PNRS II System Modifications

Careful observation of PNRS II systems and the results of Sample Event No. 1 and 2 were used to formulate recommendations for adjustments and modifications to the test systems and the GCREC pilot facility. The recommended modifications were outlined in Data Summary Reports No. 1 and 2. The issues to be addressed, modifications that the provider will implement, and expected outcomes are presented below. All recommendations are based on the overriding PNRS II goal of providing functional specifications for modular biofiltration components for passive onsite nitrogen reducing treatment systems.

Figure 1: STE Modifications

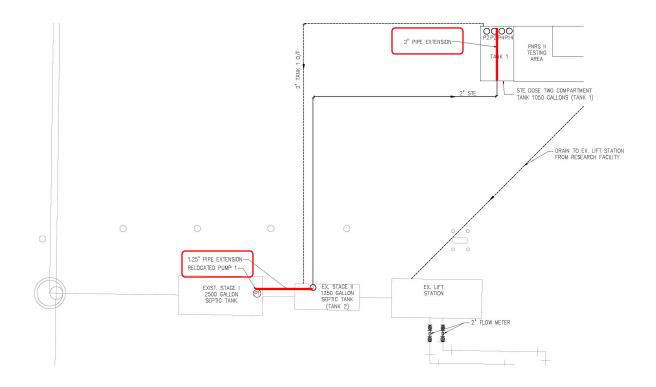
The provider will implement the following modifications to address STE quality issues as depicted in Figure 1:

- a. A hydraulic modification will be made to the two-chamber PNRS II dosing tank (Tank 1). STE from the GCREC tank enters the first chamber of the PNRS II dosing tank and then flows to the second chamber which contains the PNRS II dosing pumps. To decrease residence time, a new pipe will be installed to direct STE from the GCREC tank directly to the second chamber in the PNRS II dosing tank.
- b. Additionally, Pump 1 which withdraws STE from the GCREC septic tank will be relocated upstream of the present withdrawal tank.

Figure 2: UNSAT-PS1 Modifications

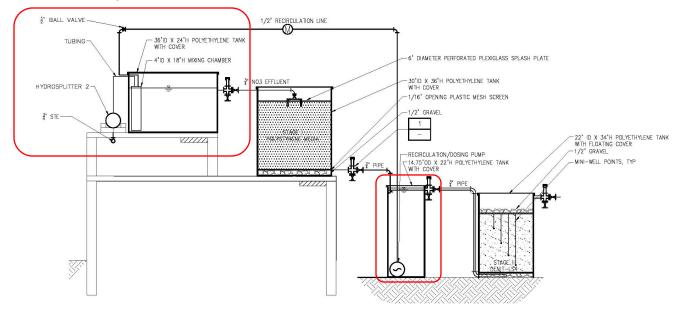
The provider will implement the following modifications to the polystyrene biofilter system as depicted in Figure 2:

- a. Addition of recirculation pump
- b. $\frac{1}{2}$ " piping from pump to recirculation tank with flowmeter

- c. Addition of recirculation tank
- d. Addition of pump tank

Figure 14: DENIT-LS2 Biofilter Modifications

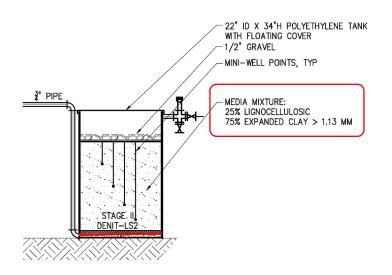
The provider will implement the following modifications as depicted in Figure 14:

- a. Replace media within DENIT-LS2 biofilter
 - i. Media mix = 25% Lignocellulosic, 75% Expanded Clay >1.13 mm
- b. Glue expanded clay fines to sides of walls to prevent wall creep
- c. Add perforated discharge pipe to bottom inlet along entire length of bottom of tank

Figure 15: DENIT-SU4 Upflow Biofilter Modifications

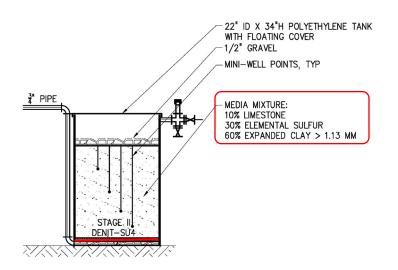
- a. Replace media within DENIT-SU4 upflow biofilter (see Figure 15)
 - i. Media mix: 10% limestone, 30% elemental sulfur, 60% Expanded Clay >1.13 mm
- b. Replace media within DENIT-SU2 horizontal biofilter (see Figure 16)
 - i. Media mix: 10% limestone, 30% elemental sulfur, 60% Expanded Clay >1.13 mm

Figure 17: IS3 and IS4 Columns

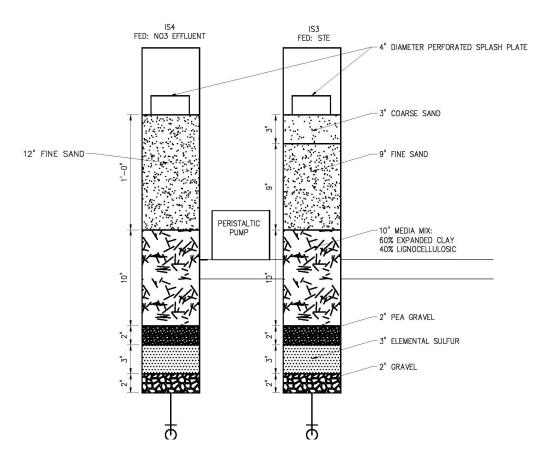
The provider will implement the following modifications as depicted in Figure 17:

- a. Construct 6" Diameter IS3 biofilter
 - i. Media used = coarse sand, fine sand, expanded clay, lignocellulosic, elemental sulfur, pea gravel and gravel
- b. Construct 6" Diameter IS4 biofilter
 - i. Media used = fine sand, expanded clay, lignocellulosic, elemental sulfur, pea gravel and gravel
- c. Addition of peristaltic pump
